City of Alexandria, Virginia

MEMORANDUM

SUBJECT: REVISED PLANS FOR 703 KING STREET, BAR CASE #2015-0062

Docket Item # 3
BAR CASE # 2015-00062

Figure 3: Historic photo of 703 King Street with bay windows

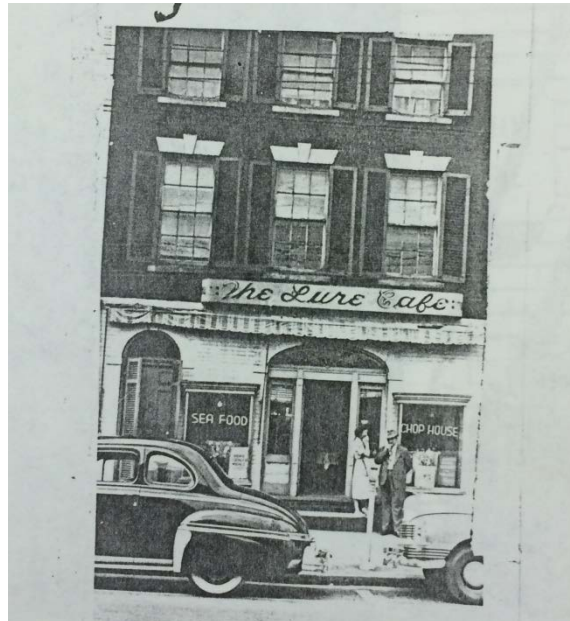
Using the photo in Figure 3 as a guide, staff has sketched one potential alternative in Figure 4 which provides additional glazing area and recalls the proportions of the Lure Café's prior door and sidelights. Regardless of the solution desired by the applicant, this redesigned feature should reflect the past use as an entrance.

Figure 4: Staff alternative suggestion for door and window panel proportions

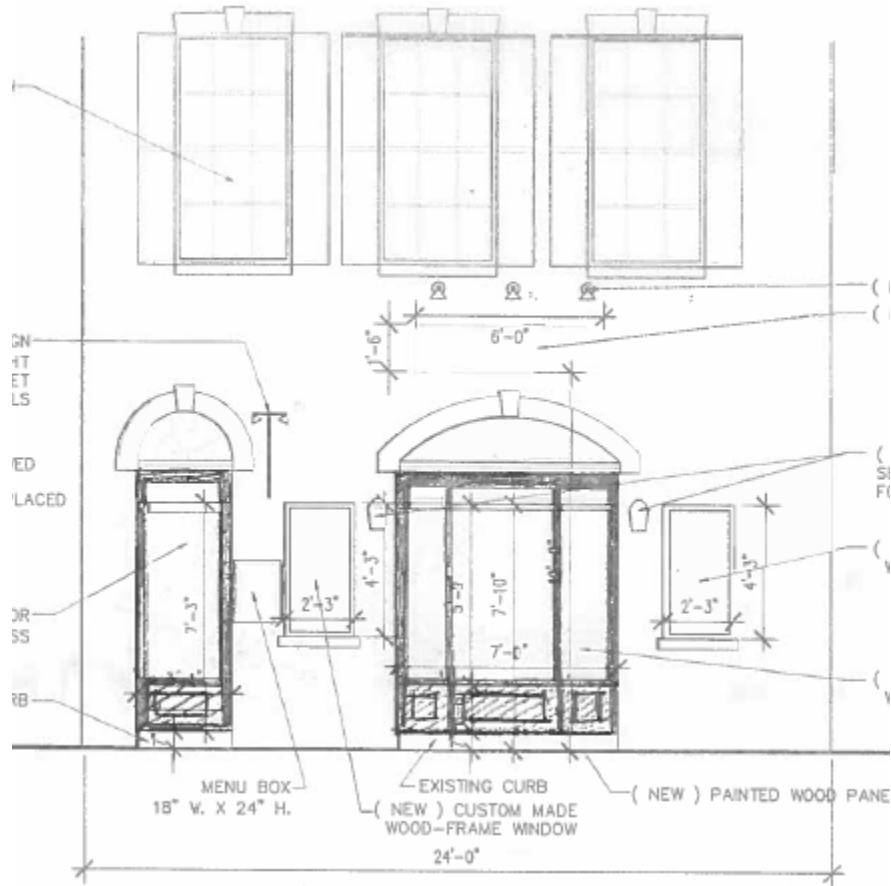
While staff does not object to the removal of the center door and the installation of a fixed window, the current configuration is incongruous with the historic building and does not give any indication to the opening's prior use as an entrance. Fortunately, a number of historic photos exist of this building (see two early 20th century examples below), providing ideas for modern solutions which recall the building's past.

Staff also recommends extending both the single door and the fixed window up to the existing transom bar to avoid the awkward dual transom appearance and to provide additional light into the space. A matching wood panel is also suggested below the single door to balance the fixed window and recall the prior doors.

1. The front window feature is redesigned, in consultation with staff, to reflect the proportions of the former use of this opening as a door, using historic photos as reference;
2. All the window and door decals are eliminated;
3. That staff verify an appropriate level of lighting in the field, so that this is not the brightest store on the block face;
4. The pin mounted wall sign is installed on a backing board, to limit damage to the historic brick façade with numerous holes; and,
5. The conduit for the mini-spot lights illuminating the pin mounted sign is internal or integrated with the backing board and conduit is not applied to the surface on the exterior of the building.

Proposed main sign

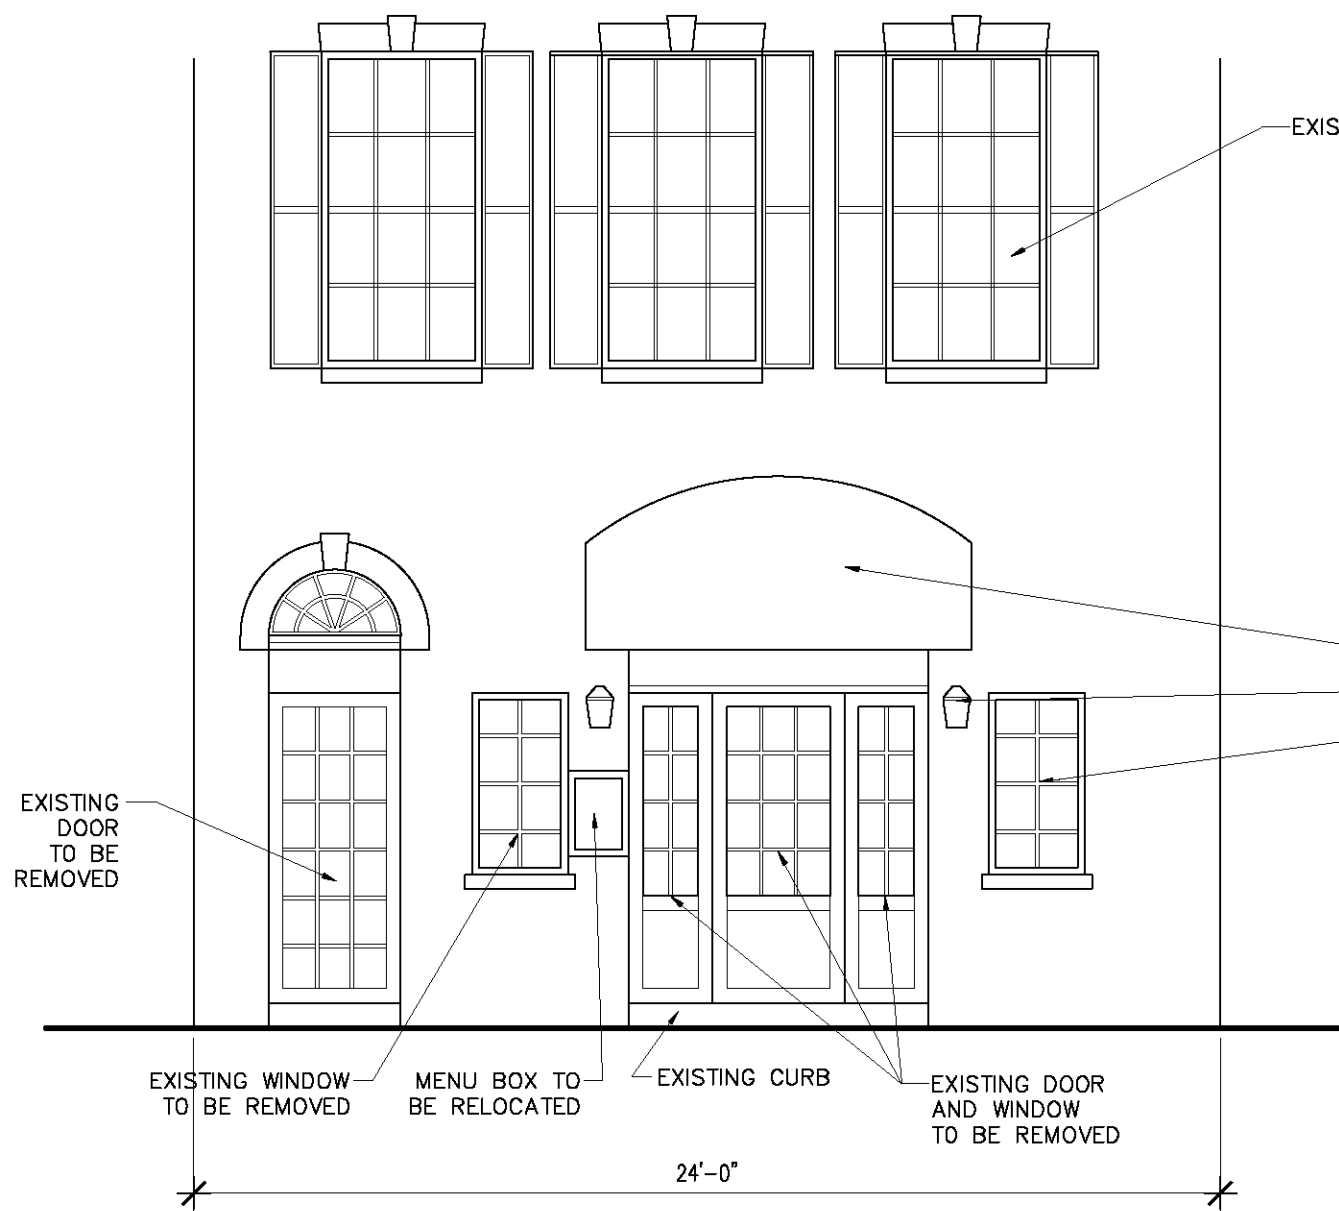
Because the amount of signage originally proposed by the applicant exceeds what is permitted by the zoning ordinance, the applicant has elected to delete the window signs on the small windows adjacent to the proposed fixed window. While the *Design Guidelines* recommend only one sign per business, the Board's Sign Policy allows for up to two signs per business. Staff finds that three different sign types – a wall sign, hanging sign and window/door decals - are excessive given the relatively small amount of street frontage. Instead, staff recommends approval of the wall sign and the hanging sign. The hanging sign will provide visibility for pedestrians, while the wall sign will provide visibility for vehicles. The deletion of the window signs will also allow for greater visibility into the proposed restaurant, which is a stated goal of the applicant. While Staff does not object to the installation of a wall sign, on brick buildings the guidelines generally recommend that they be mounted on a backing board so as not to create numerous holes in the historic brick and mortar.

② **PROPOSED DESIGN**
1/4" = 1'-0"

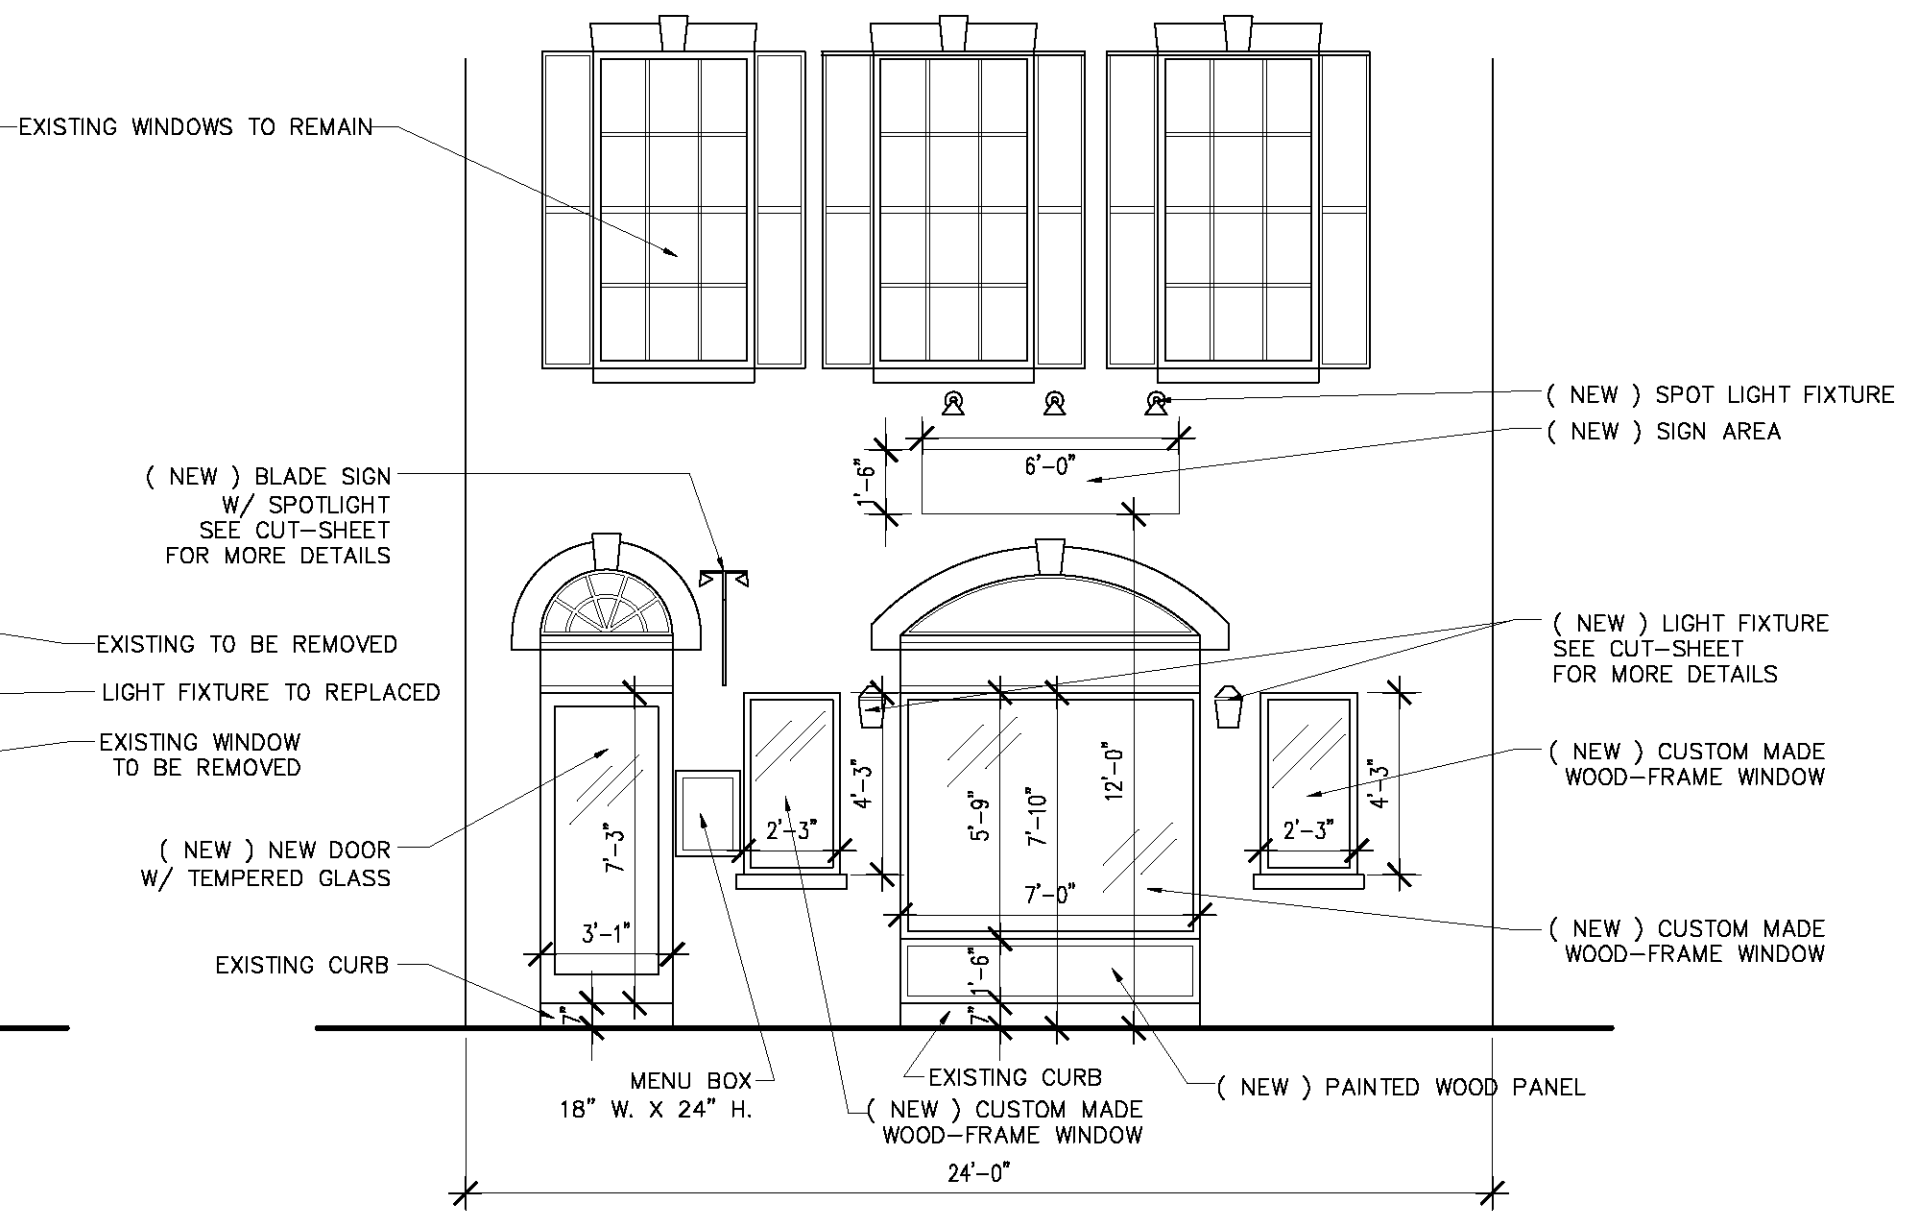
As the Board may be aware, this retail space has turned over numerous times over the last few decades. The applicant believes that the failure of these establishments was, in part, due to the lack of transparency into the building, the amount of floor area required to use the present large entry doors, and that the proposed alterations will help to make the proposed restaurant more successful. Given the numerous alterations to the first floor of the building since its construction and the lack of remaining historic fabric in this area, staff is generally supportive of the proposed modifications to this portion of the building. Staff strongly supports removal of the present awning, as this was out of scale and hid the elliptical arch, one of the primary character defining features of the building. However, staff has two concerns: the design of the new front window and the amount of signage proposed for such a small building.

Staff is also concerned that the cumulative amount of proposed lighting on this small façade may be excessive and recommends that it be examined by staff at night in the field to verify that it is uniform and does not become the brightest store on the block face. This can be adjusted easily, if necessary, by using bulbs with lower lumens or a different temperature range. The applicant should also install the conduit for the wall lighting through the building wall so it is not affixed to the outside of the building.
